COMMUNITY DEVELOPMENT DEPARTMENT

HEARING DATE: 5/24/2022

SUBJECT: H-2022-0024
Timberline North (Timberline No. 2) PFP

Combined Preliminary and Final Plat for 33 single-family residential building lots and 4 common lots on 9.8 acres of land in the R-8 zoning district for the purpose of subdividing phase 2 of the Timberline Subdivision (H-2017-0140, DA# 114007668) that has since expired.

TIMBERLINE SUBDIVISION NO. 2

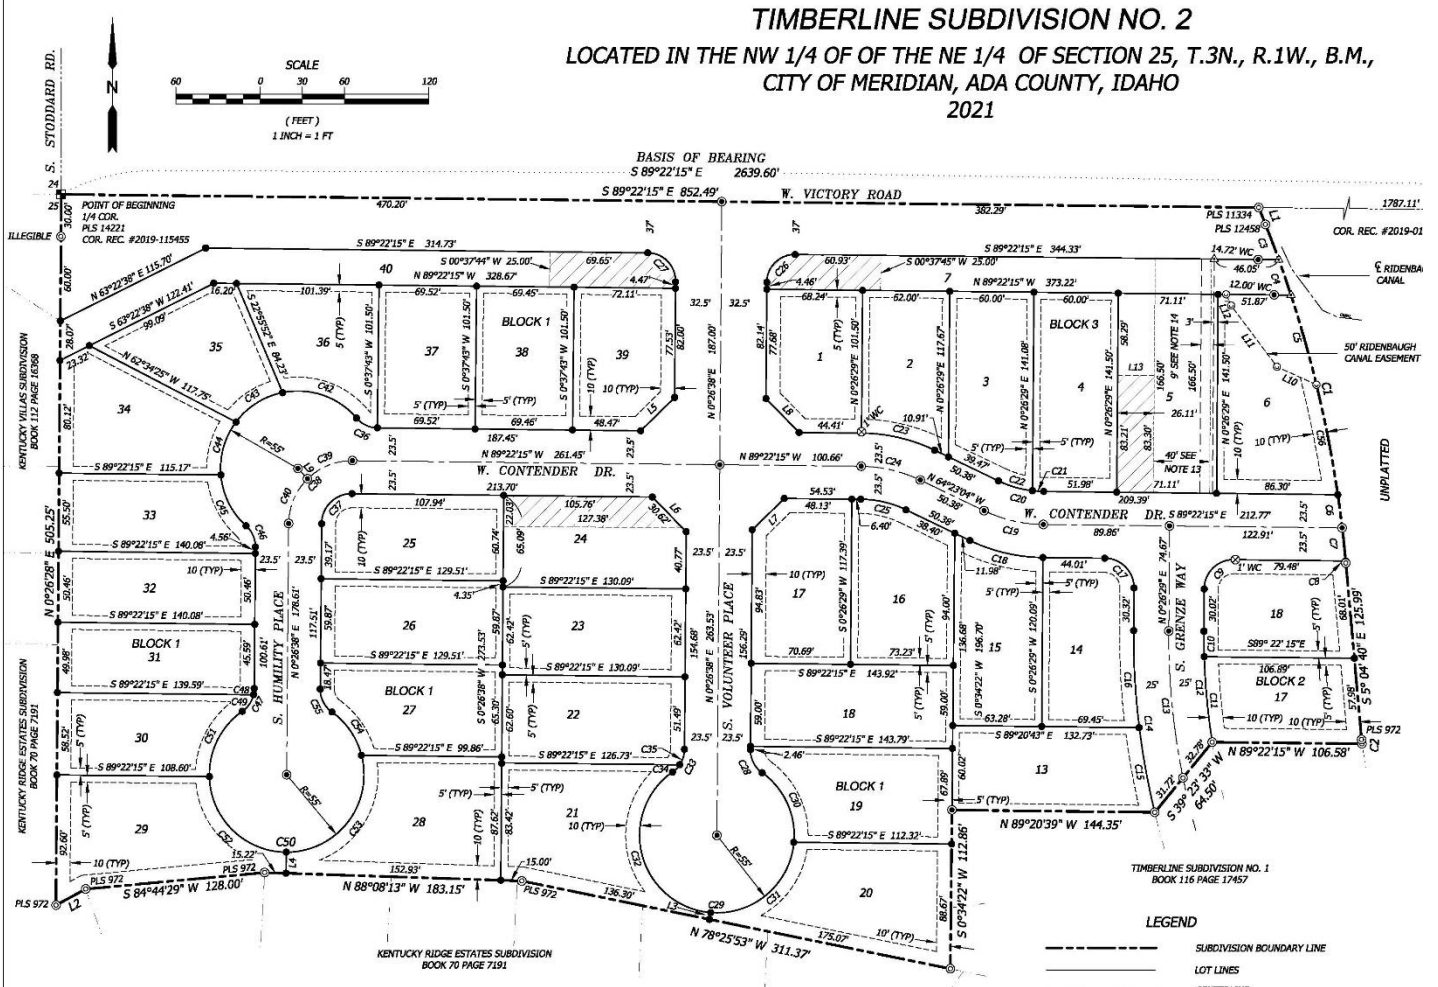
3. The final plat prepared by Sawtooth Land Surveying, LLC, with a stamped date of ~~January 12, 2022~~ May 2, 2022, is approved as submitted. ~~shall be revised as follows at the time of Final Plat Signature submittal:~~

- a. ~~Note #5 shall be corrected to show read "...Title 11 of Meridian City Code..." instead of "Title II..."~~
 - b. ~~Note #14 add applicable instrument number.~~

C. Landscape Plan (dated: January 2020)

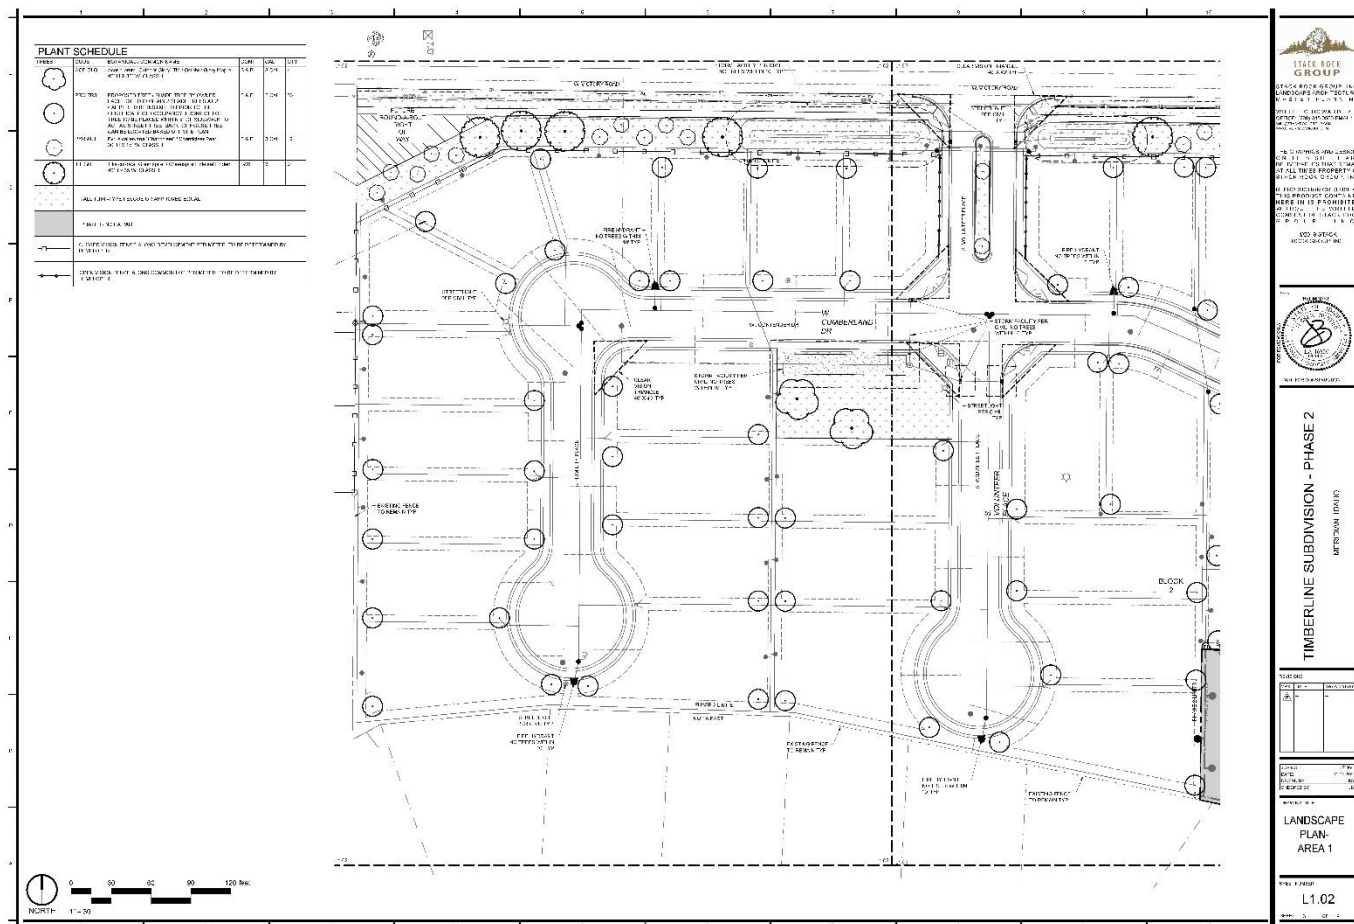
- c. ~~Add ACHD R/W Instrument number on final plat where ultimate right of way is shown.~~
4. The submitted landscape plan prepared by Stack Rock Group, with a stamped date of May 2, 2022, is approved as submitted. ~~dated 01/14/2020 shall be revised as follows at the time of Final Plat Signature submittal:~~

- a. ~~With submittal of the final plat Mylar application, the applicant shall provide a revised landscape plan per UDC requirements and standards set forth in 11-3B-7C.5a: "If the unimproved street right of way is ten feet (10') or greater from the edge of pavement to edge of sidewalk or property line, the developer shall maintain a ten foot (10') compacted shoulder meeting the construction standards of the transportation authority and landscape the remainder with lawn or other vegetative ground cover. (Ord. 16-1672, 2-16-2016)." This condition shall be applied to the Northwest corner of the property abutting W. Victory Road.~~
